11-08 LATEST REVISION DATE	<i>Thomas E. McQuinn</i> APPROVED BY BRIDGE ENGINEER	 Iowa Department of Transportation Highway Division	
		STANDARD DESIGN - 40' ROADWAY, 3 SPAN BRIDGES CONTINUOUS CONCRETE SLAB BRIDGES NOVEMBER, 2006	
		ABUTMENT DETAILS 15° SKEW - TIMBER PILING	J40-33-06

PILE PLAN - 15° SKEW WOOD PILING

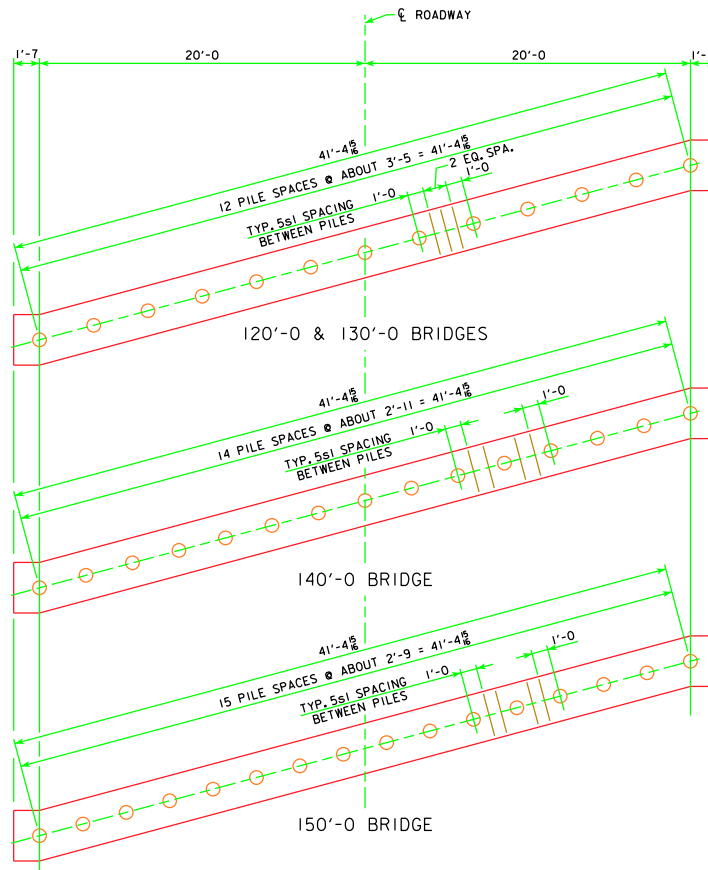
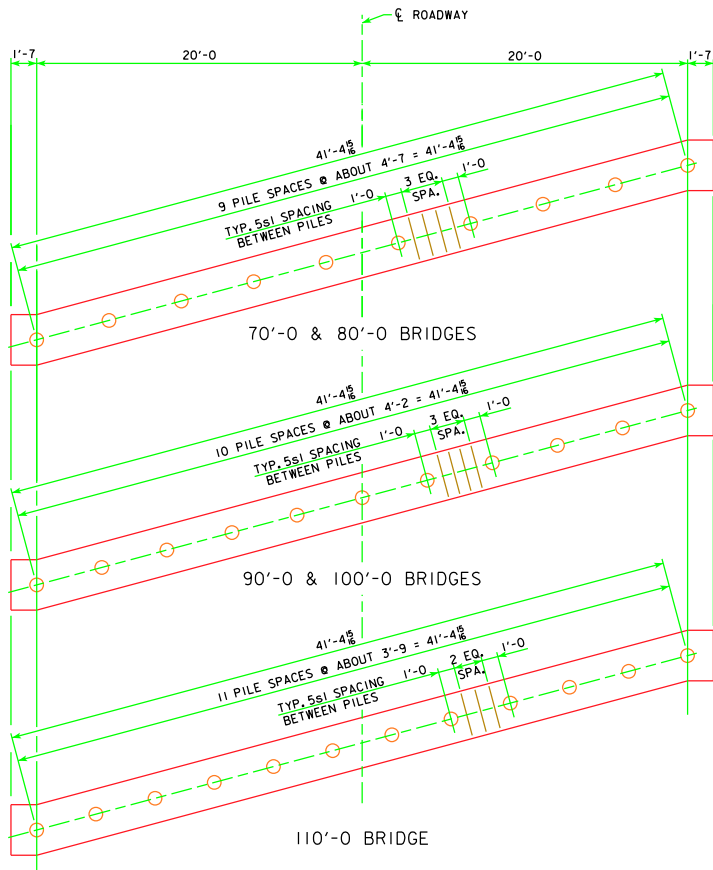
REVISED 11-08 - REVISED NUMBER OF PILES FOR 70'-0 BRIDGE.
